ADDENDUM NUMBER 1

DATE: 05/12/2025

PROJECT: City Hall Restroom Renovation

PROJECT NUMBER: 0100-0569

FLOOR PLAN AND REFLECTED CEILING DEMOLITION PLAN

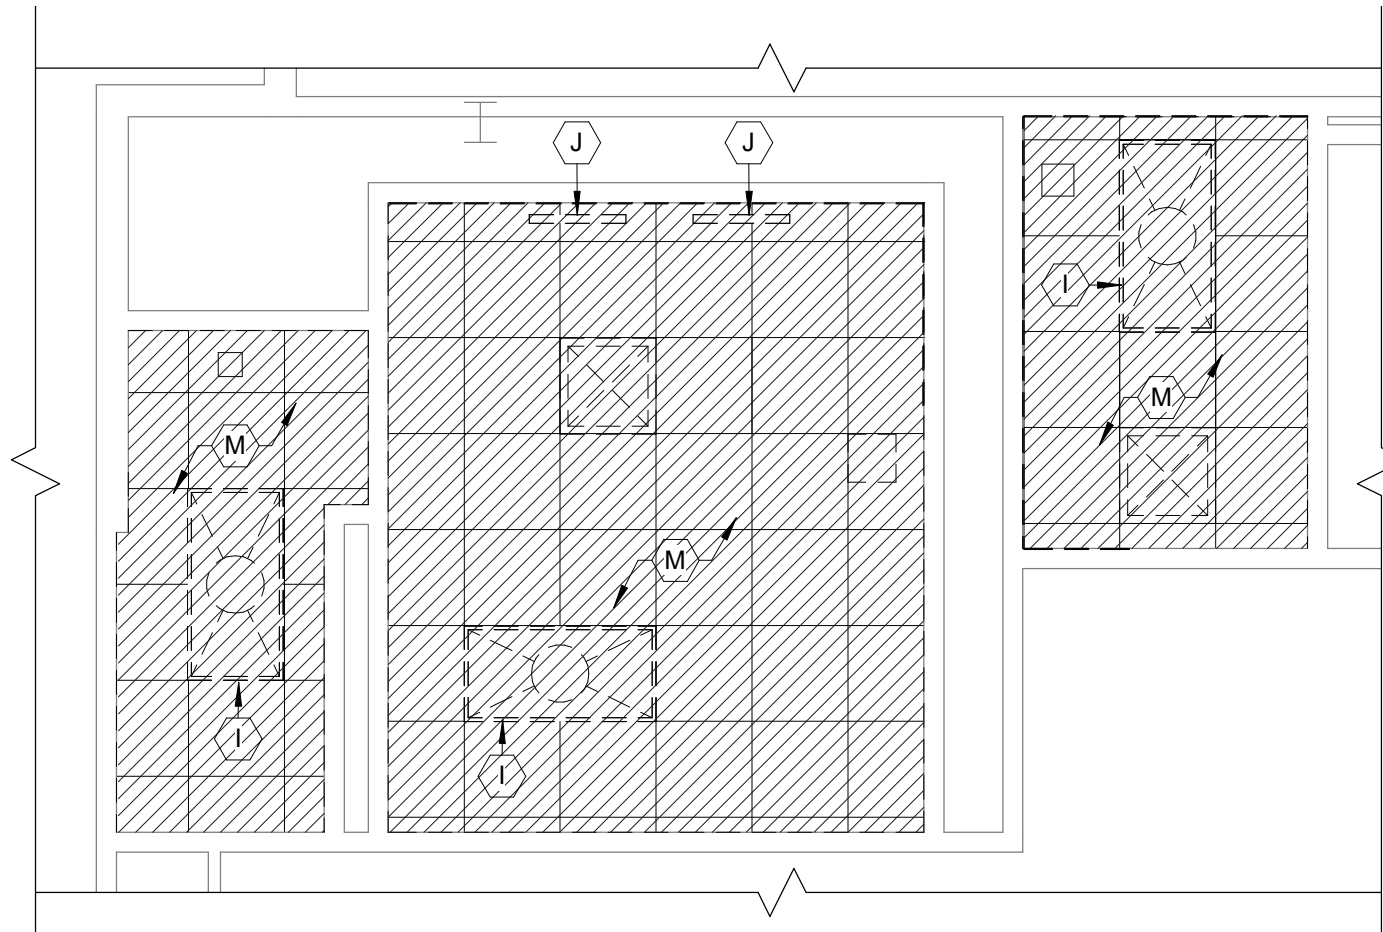
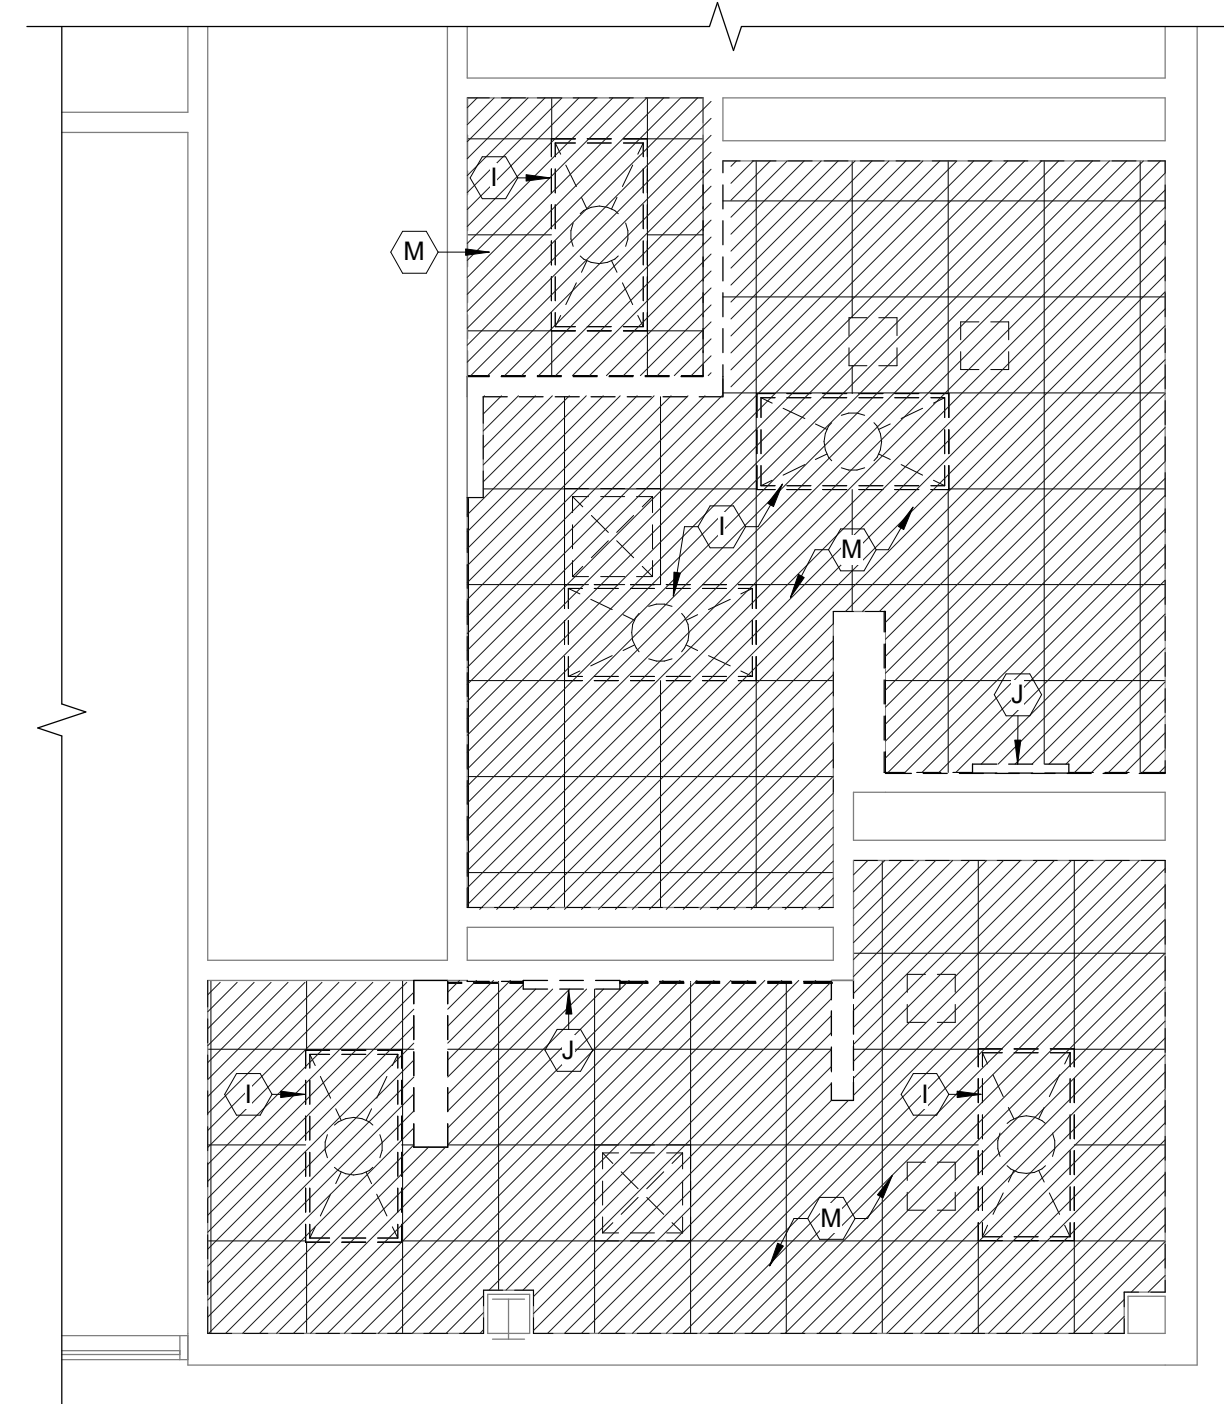
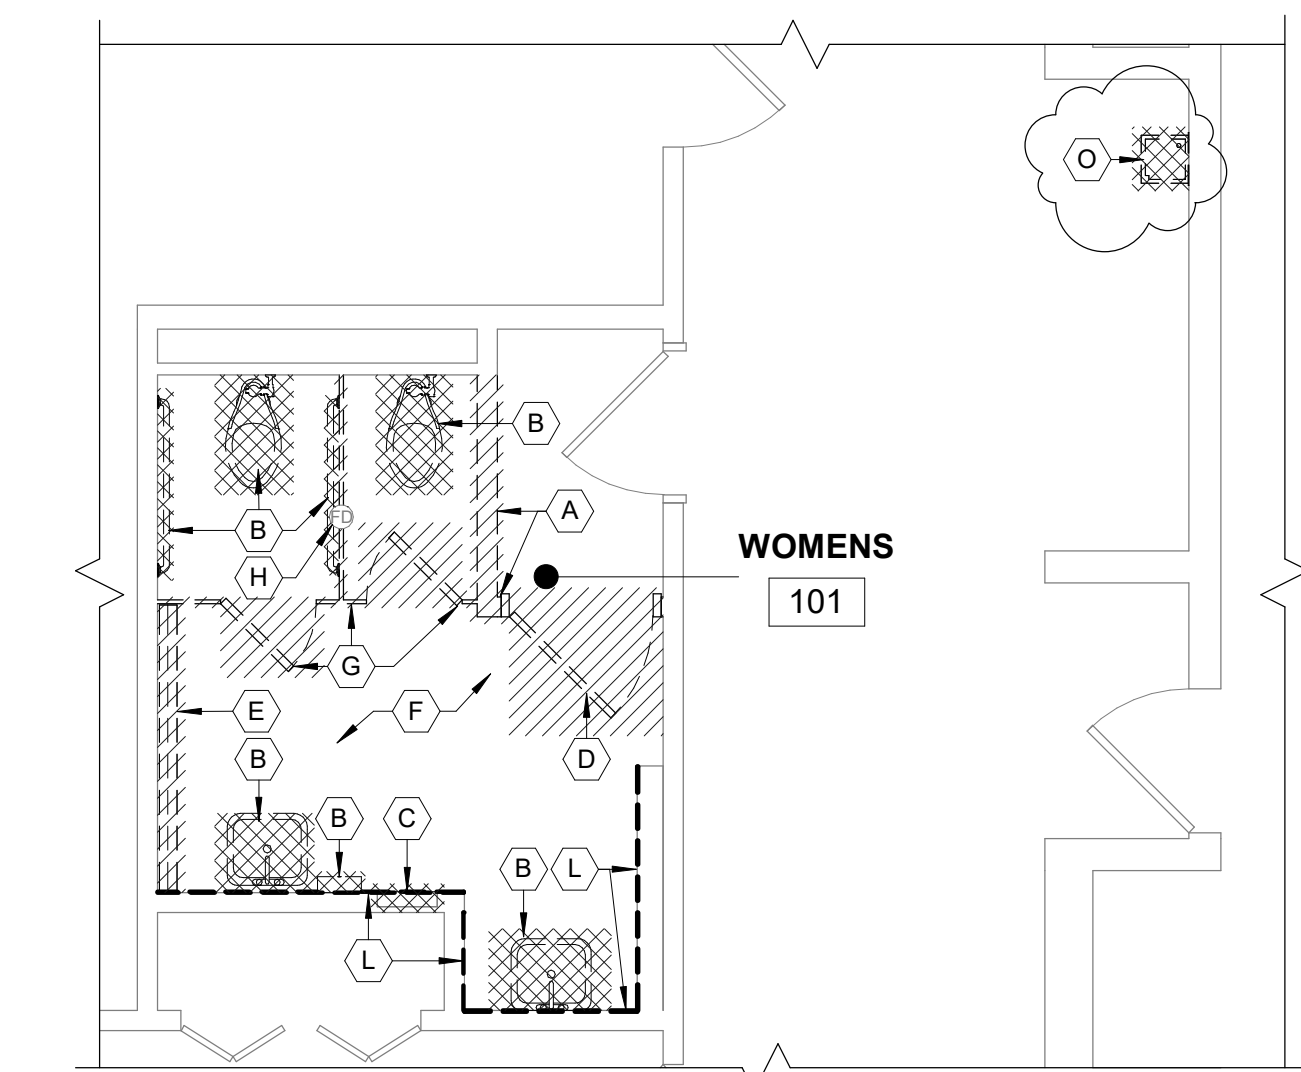
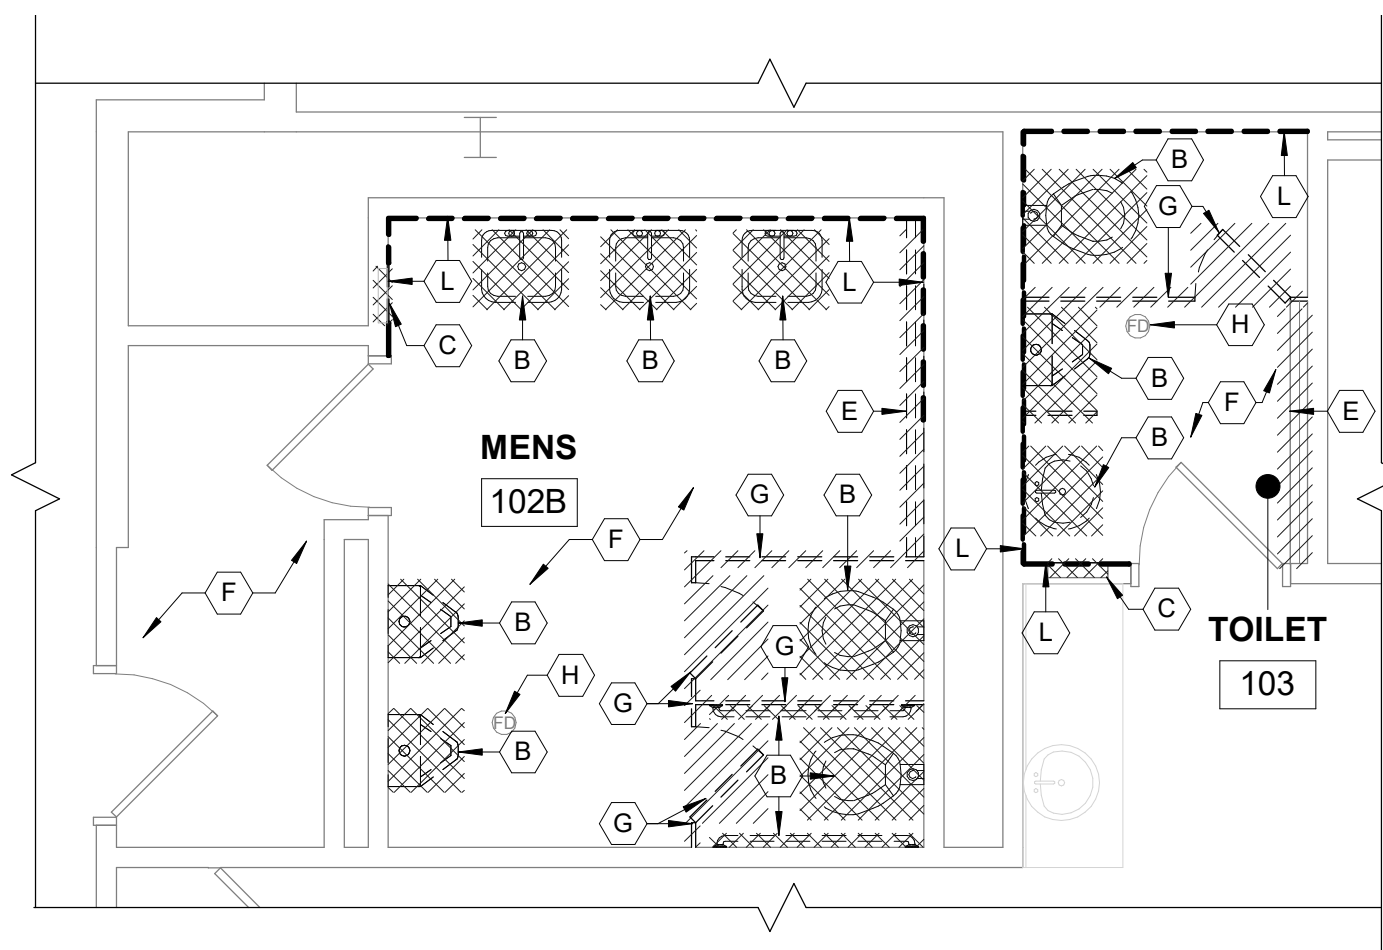
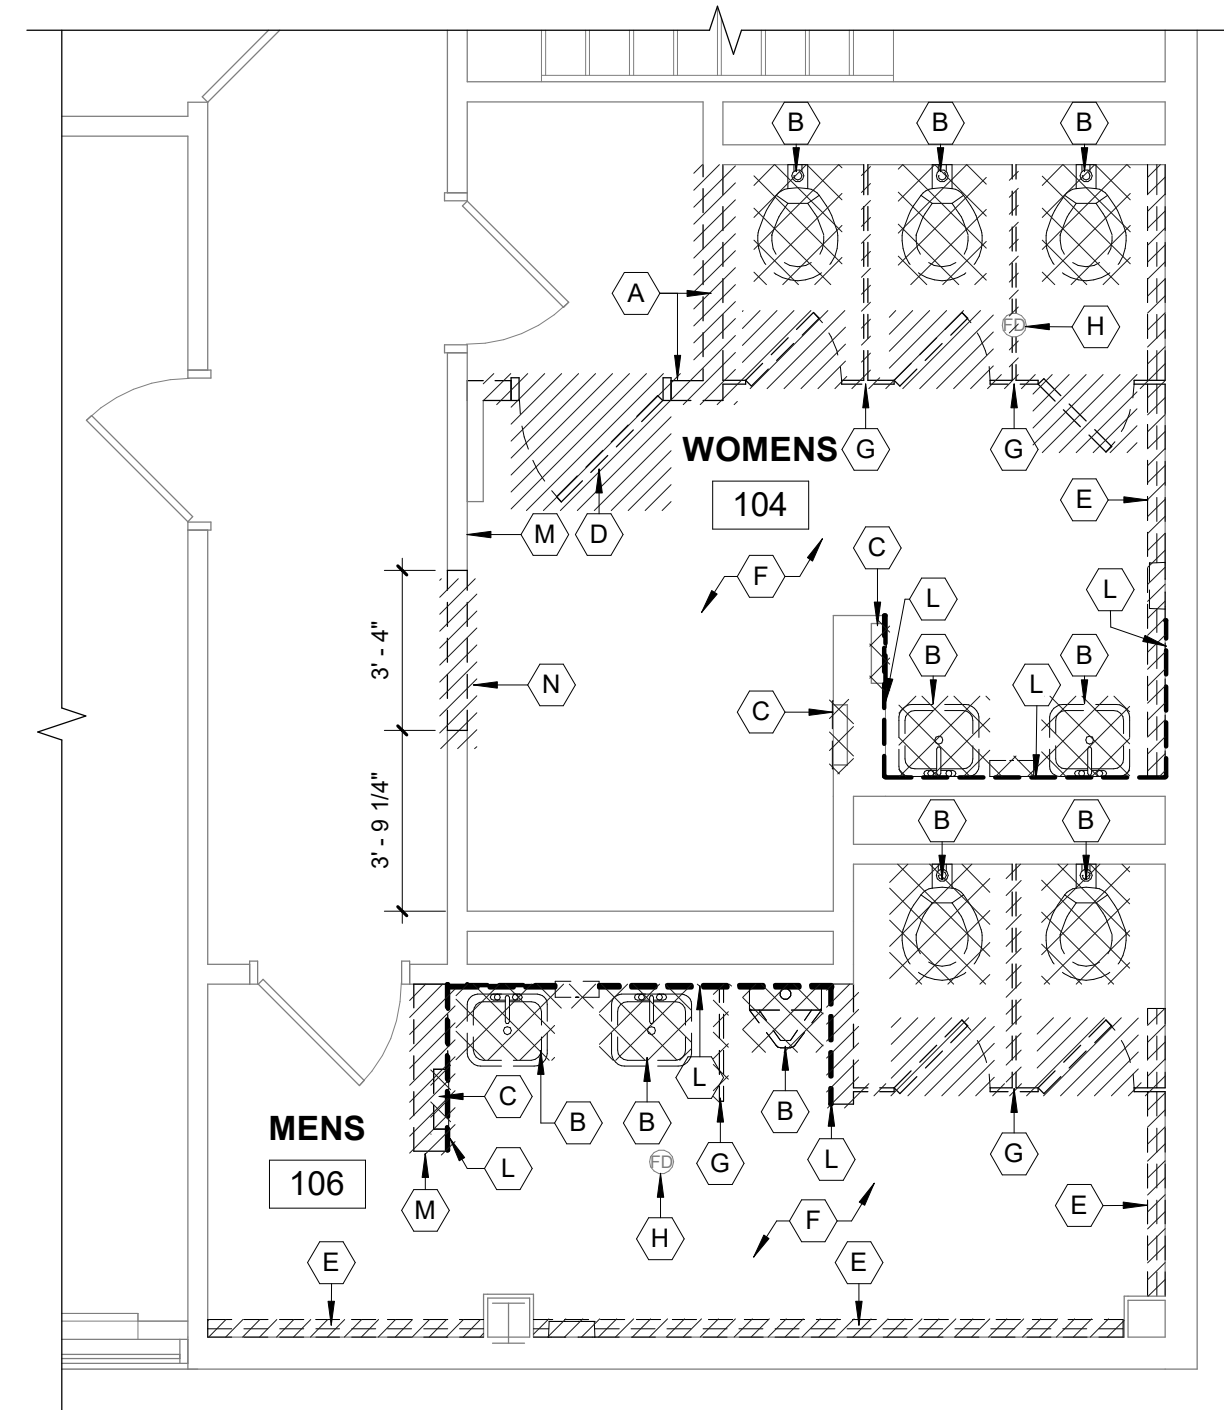
18. **Q:** Drawing AD101- Note F indicates to remove the flooring and base entirely, prep for new. Please advise if the existing floor tile is installed on a mud-set or on a thin-set method. Is the existing floor tile installed on a slab on grade or on an existing hollow core system.

19. **Q:** Drawing AD101- Note L indicates to remove wall tile entirely, prep for new finish. Please advise if the existing walls behind the existing wall tile is CMU or Drywall Partitions. In addition, please advise on the installation method for the new wall tile. I.E., Mud-set or Thin-Set.

3. SHEET AD101: reissued
 - a. Added demolition of floor drains, updated keynote H
 - b. Added demolition of drinking fountain outside of Womens 101 and keynote O

- c. Added to Keynote L – replace drywall and prep for new finish
4. SHEET A100: reissued
 - a. Added demolition of drinking fountain
5. SHEET A401: reissued

- (F) REMOVE FLOORING AND BASE ENTIRELY, PREP FOR NEW
- (G) REMOVE TOILET AND URINAL PARTITIONS COMPLETELY, PATCH WALL AND PREP FOR NEW FINISH
- (H) EXISTING FLOOR DRAIN TO BE REMOVED, PREP FOR NEW

- (I) REMOVE EXISTING LIGHT FIXTURES
- (J) REMOVE WALL MOUNTED LIGHT FIXTURES
- (K) EXISTING SPRINKLERS TO REMAIN
- (L) REMOVE WALL TILE ENTIRELY, REPLACE DRYWALL AND PREP FOR NEW FINISH

- (M) REMOVE THERMOSTAT
- (N) REMOVE PARTITION AND PREP FOR NEW DOOR
- (O) REMOVE DRINKING FOUNTAIN IN WALL PROVIDE CLEANOUT CHROME CAPE FOR THE BLUGGED WASTE PIPE IN WALL. PROVIDE CHROME CAP FOR THE CAPPED COLDWATER IN
